944 Turbo Brake Callpers (Identical Parts of 928 S 4)

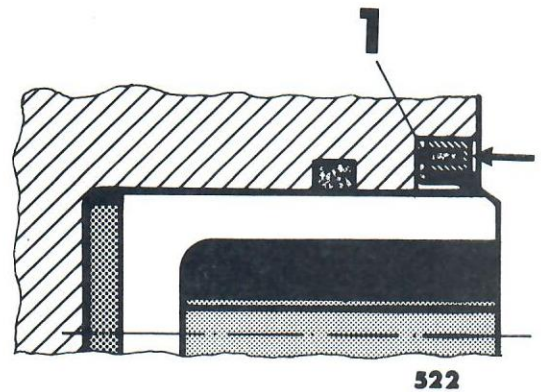
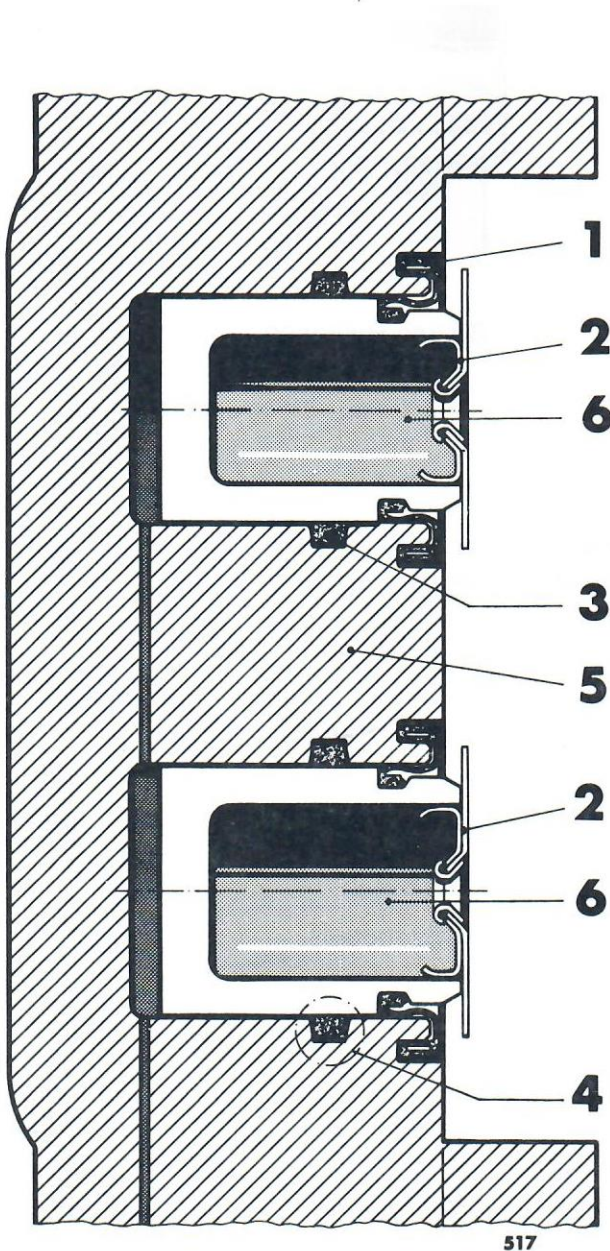
The brake piston scraper rings, used previously on the four piston brake callpers (Brembo make) for front and rear wheels, are replaced with special dust caps. Function is improved with help of these changes.

- Reduction of piston displacement force.
- Less piston and cylinder wear.
- Reduction of residual friction after application of brakes.

For these reasons it is **Important to make sure that only brake callpers of the same type are installed on one axle for repairs.**

Old Version:
 Dust cap sealed off the piston surface by sliding on it.
 Can be recognized on the steel insert (arrow) of the seal.
